OGRR Number	208	OGRR Title	Voltage Ride-Through (VRT) Requirement
--------------------	------------	-------------------	---

Date	November 7, 2008
-------------	------------------

Submitter's Information	
Name	Joint Comments from E.ON, Invenergy and Horizon (John Moore, Kris Zadlo, and Brian Hayes)
E-mail Address	mailto: john.moore@eon.com , kzadlo@invenergyllc.com , and brian.hayes@horizonwind.com
Company	E.ON, Invenergy and Horizon
Market Segment

OGRR 208 VRT

Figure 1: Voltage Ride-Through Boundaries For Wind-powered Generation Resources

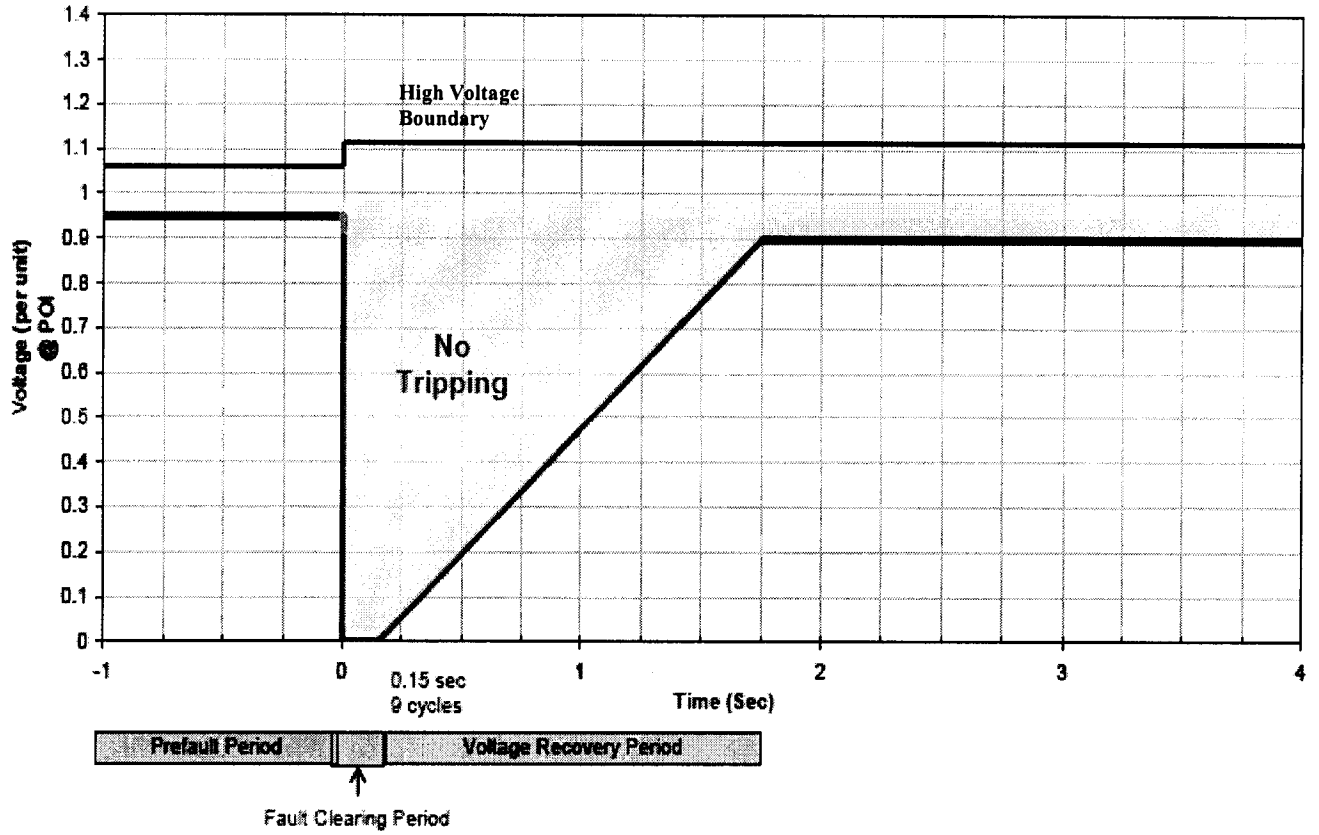
- Wind-powered Generation Resources (WGRs) specified below are required to set generator voltage relays to remain in-service during all transmission faults (no more than nine (9) cycles) in accordance with Figure 1, Voltage Ride-Through Boundaries For ~~Generating Units~~, Wind-powered Generation Resources, below. Faults on individual phases with delayed clearing (zone 2) may result in phase voltages outside this boundary but if the phase voltages remain inside this boundary then generator voltage relays are required to be set to remain connected and recover within the voltage recovery boundary of Figure 1.

- -WGR voltage relays shall be set to remain interconnected during three-phase faults on the transmission system for a voltage level as low as zero volts with a duration no more than nine (9) cycles as measured at the point of interconnection as shown in Figure 1. The clearing time requirement for a three-phase fault will be specific to the generating plant point of interconnection, as determined by and documented by the transmission provider in conjunction with the interconnection agreement. This requirement does not apply to faults that would occur between the generator terminals and the transmission voltage side of the generation step-up transformer or when clearing the fault effectively disconnects the generator from the system.

- WGRs may be tripped after the fault period if this action is intended as part of a special protection system.
- WGRs may meet the VRT requirements of Figure 1 by the performance of the generators or by installing additional equipment (e.g., Static VAR Compensator) within the generating plant or by a combination of generator performance and additional equipment.

- Existing individual WGRs that are replaced are required to meet the requirements of Figure 1.
- ~~Existing individual WGRs that are part of a Generation Interconnect Agreement signed prior to January 1, 2003 are exempt from the requirements of Section 3.1.4.6.1, Protective Relaying Requirement and Voltage Ride-Through Requirement for Wind-powered Generation Resources.~~

- ~~WGRs that are part of a Generation Interconnect Agreement signed after January 1, 2003 and before November 1, 2008 shall meet the requirements of Section 3.1.4.6.1 by January 1, 2015.~~

- WGRs that are part of a Generation Interconnect Agreement signed after November 1, 2008 shall meet the requirements of Section 3.1.4.6.1, Protective Relaying Requirement and Voltage Ride-Through Requirement for Wind-powered Generation Resources. All such WGRs shall provide a status of compliance to ERCOT System Planning by July 1, 2009.

- WGRs that are part of a Generation Interconnect Agreement signed prior to November 1, 2008 shall provide information requested by ERCOT, including existing WGR VRT capabilities, for a study to evaluate the need for additional protective relaying and VRT requirements applicable to some or all such WGRs. If the results of the study demonstrate the need, this Operating Guide shall be revised to establish those requirements, including a schedule for compliance. ERCOT shall publish study results and provide recommendations to ROS by the scheduled ROS meeting of June 2010

- ~~All WGRs shall provide a status of compliance with the requirements of Section 3.1.4.6.1 to ERCOT System Planning by July 1, 2009.~~
- ~~All non-exempt WGRs shall provide an implementation plan for compliance with the requirements of Section 3.1.4.6.1 to ERCOT System Planning by July 1, 2009.~~

- Notwithstanding any allowed exemptions of the foregoing provisions, existing individual WGRs that meet the requirements of Figure 1 on November 1, 2008 shall continue to meet the requirements of Figure 1.

- If, due to a system disturbance, a WGR come off-line within the boundaries of the VRT requirement of Figure 1, then the WGR owner and the TSP shall be required to investigate and report to ERCOT on the cause of the WGR trip identifying a reasonable mitigation plan and timeline.

Figure 1: Voltage Ride-Through Boundaries For Wind-powered Generation Resources

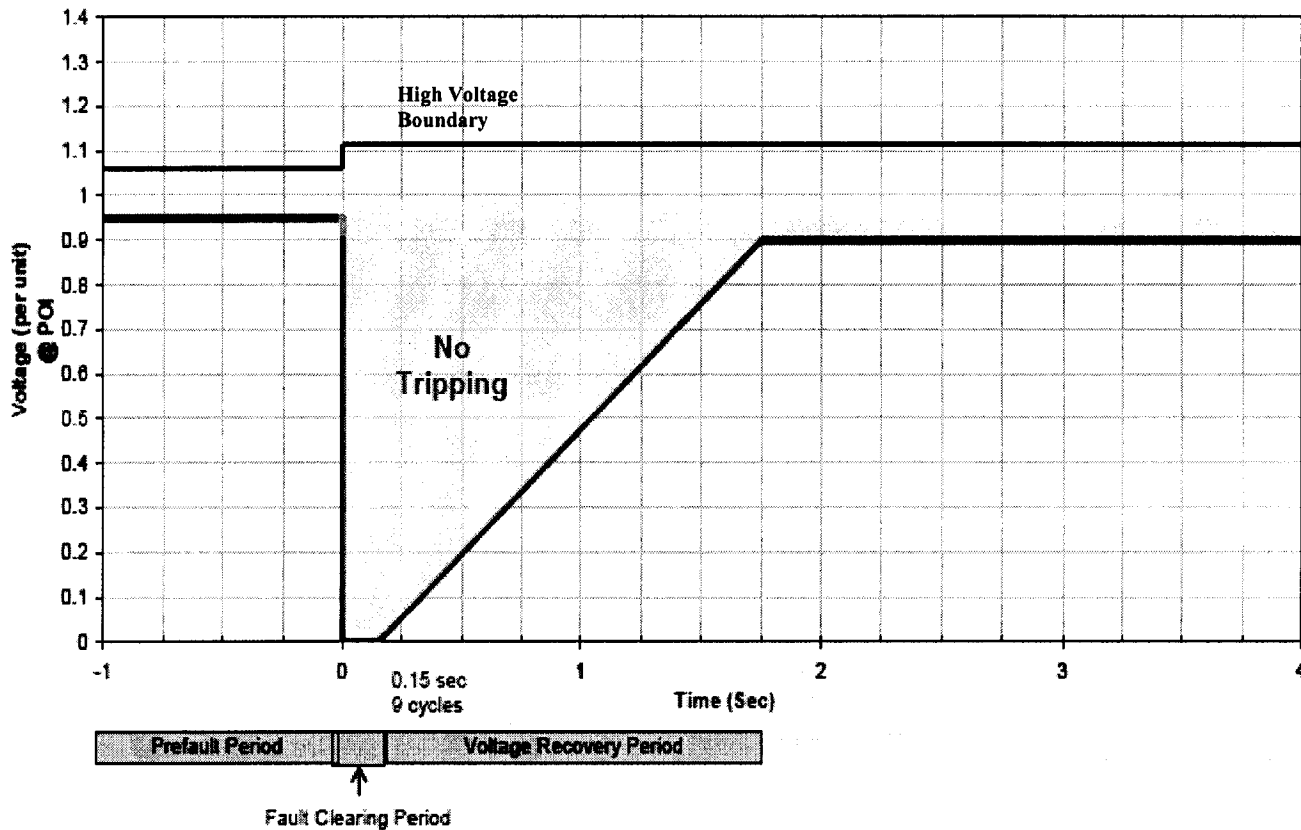
- Wind-powered Generation Resources (WGRs) specified below are required to set generator voltage relays to remain in-service during all transmission faults (no more than nine (9) cycles) in accordance with Figure 1, Voltage Ride-Through Boundaries For ~~Generating Units~~, Wind-powered Generation Resources, below. Faults on individual phases with delayed clearing (zone 2) may result in phase voltages outside this boundary but if the phase voltages remain inside this boundary then generator voltage relays are required to be set to remain connected and recover within the voltage recovery boundary of Figure 1.

- -WGR voltage relays shall be set to remain interconnected during three-phase faults on the transmission system for a voltage level as low as zero volts with a duration no more than nine (9) cycles as measured at the point of interconnection as shown in Figure 1. The clearing time requirement for a three-phase fault will be specific to the generating plant point of interconnection, as determined by and documented by the transmission provider in conjunction with the interconnection agreement. This requirement does not apply to faults that would occur between the generator terminals and the transmission voltage side of the generation step-up transformer or when clearing the fault effectively disconnects the generator from the system.

- WGRs may be tripped after the fault period if this action is intended as part of a special protection system.
- WGRs may meet the VRT requirements of Figure 1 by the performance of the generators or by installing additional equipment (e.g., Static VAr Compensator) within the generating plant or by a combination of generator performance and additional equipment.

- Existing individual WGRs that are replaced are required to meet the requirements of Figure 1.
- ~~Existing individual WGRs that are part of a Generation Interconnect Agreement signed prior to January 1, 2003 are exempt from the requirements of Section 3.1.4.6.1, Protective Relaying Requirement and Voltage Ride-Through Requirement for Wind-powered Generation Resources.~~

- ~~WGRs that are part of a Generation Interconnect Agreement signed after January 1, 2003 and before November 1, 2008 shall meet the requirements of Section 3.1.4.6.1 by January 1, 2015.~~

- WGRs that are part of a Generation Interconnect Agreement signed after November 1, 2008 shall meet the requirements of Section 3.1.4.6.1, Protective Relaying Requirement and Voltage Ride-Through Requirement for Wind-powered Generation Resources. All such WGRs shall provide a status of compliance to ERCOT System Planning by July 1, 2009.

- WGRs that are part of a Generation Interconnect Agreement signed prior to November 1, 2008 shall provide information requested by ERCOT, including existing WGR VRT capabilities, for a study to evaluate the need for additional protective relaying and VRT requirements applicable to some or all such WGRs. If the results of the study demonstrate the need, this Operating Guide shall be revised to establish those requirements, including a schedule for compliance.

- ~~All WGRs shall provide a status of compliance with the requirements of Section 3.1.4.6.1 to ERCOT System Planning by July 1, 2009.~~
- ~~All non-exempt WGRs shall provide an implementation plan for compliance with the requirements of Section 3.1.4.6.1 to ERCOT System Planning by July 1, 2009.~~

- Notwithstanding any allowed exemptions of the foregoing provisions, existing individual WGRs that meet the requirements of Figure 1 on November 1, 2008 shall continue to meet the requirements of Figure 1.

- If, due to a system disturbance, a WGR come off-line within the boundaries of the VRT requirement of Figure 1, then the WGR owner and the TSP shall be required to investigate and report to ERCOT on the cause of the WGR trip identifying a reasonable mitigation plan and timeline.
